# UNITED STATES PATENT AND TRADEMARK OFFICE

| APPLICATION NO. | FILING DATE | FIRST NAMED INVENTOR | ATTORNEY DOCKET NO. | CONFIRMATION NO. |
|-----------------|-------------|----------------------|---------------------|------------------|
| 10/591,084      | 03/26/2007  | Cesar Astiz Montoya  | 2004P00286WOUS      | 7830             |

| <b>Office Action Summary</b> | <b>Application No.</b><br>10/591,084 | <b>Applicant(s)</b><br>ASTIZ MONTOYA ET AL. |  |

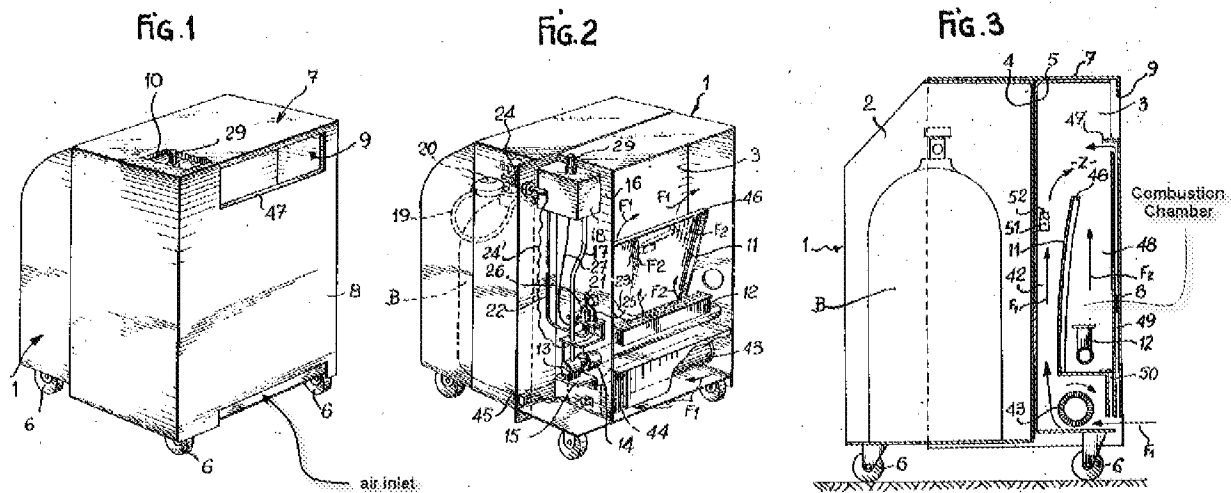
3. In re claim 27, with reference to figures 1-3 below, Antargaz discloses a gas heating device (1) comprising: a gas burner (12) including a combustion chamber (referenced in figure 3 below) for the flames of the gas burner; and a convection air conduit (3) including an air outlet (9) evacuating a convection air stream (F1) that has been heated in the gas heating device, the combustion chamber of the gas burner being in fluid-flow communication with the convection air conduit and mixing an exhaust gas stream from the combustion chamber with the convection air stream (*see at least* figure 3).

4. In re claim 28, with reference to figures 1-3 above, Antargaz discloses all of the claim limitations including wherein the gas burner (12) is located inside the convection air conduit (3).

5. In re claim 29, with reference to figures 1-3 above, Antargaz discloses all of the claim limitations including wherein the convection air conduit (3) includes a first air duct (48) and a second air duct (42).

6. In re claim 30, with reference to figures 1-3 above, Antargaz discloses all of the claim limitations including wherein the gas burner (12) faces the first air duct (48).

7. In re claim 31, with reference to figures 1-3 above, Antargaz discloses all of the claim limitations including wherein the second air duct (42) is located behind the gas burner (12).

8. In re claim 32, with reference to figures 1-3 above, Antargaz discloses all of the claim limitations including wherein a control element (52) is located in the second air duct (42).

9. In re claim 33, with reference to figures 1-3 above, Antargaz discloses all of the claim limitations including wherein at least one swirling element (46) is arranged in the air duct (48) which adjusts a residence time of secondary air in the area of the gas burner (12).

10. In re claim 34, Antargaz discloses all of the claim limitations including wherein the swirling element (46) at least partially surrounds the gas burner (12) in a funnel shape (see figures 2 and 3 above).

12. In re claim 36, with reference to figures 1-3 above, Antargaz discloses all of the claim limitations including wherein the gas burner (12) comprises a burner plate including a plurality of flame outlet openings (see figure 2 above).

45. However, with reference to figures 1-3 above, Antargaz discloses a gas heating device (1) in which the convection air conduit (3) includes an air outlet (9) evacuating a convection air stream (F1) that has been heated in the gas heating device and the combustion chamber (referenced in figure 3 above) of the gas burner (12) is in fluid-flow communication with the

convection air conduit (3) and mixes an exhaust gas stream (F2) from the combustion chamber with the convection air stream (F1).

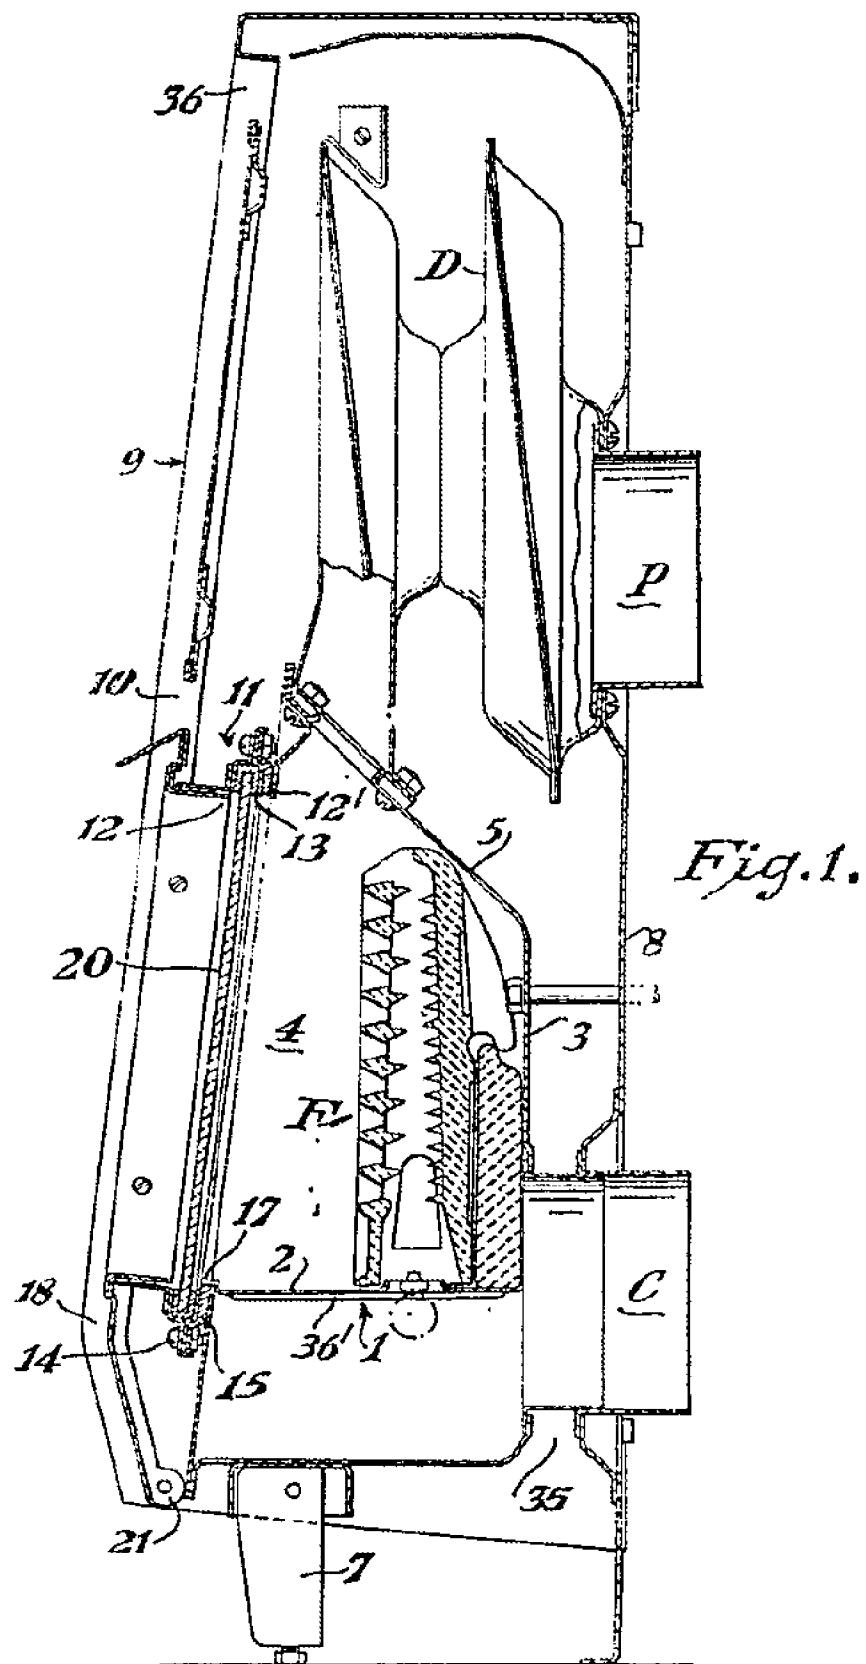
30. Nonetheless, with reference to figure 1 below, Fuidge discloses a gas space/room heater that heats by both radiation and convection wherein a radiation-transmitting element (20) is a square/rectangle formed from at least one of glass and glass ceramic (see page 2, lines 119-129).

35. In re claim 39, with reference to figure 1 of Fuidge above, Antargaz in view of Fuidge discloses all of the claim limitations including wherein the radiation-transmitting element (20) is located in a direction of thermal emission of the gas burner (F).

37. Nonetheless, with reference to figure 1 of Fuidge above, Fuidge discloses a gas space/room heater that heats by both radiation and convection wherein a window-like recess (12) is provided in the front housing portion (9) in the direction of thermal radiation of the gas burner (F).

39. In re claim 47, with reference to figure 1 of Fuidge above, Antargaz in view of Fuidge discloses all of the claim limitations including wherein the radiation window (12) of the front housing portion is closed by means of a radiation-transmitting square or rectangle (20).
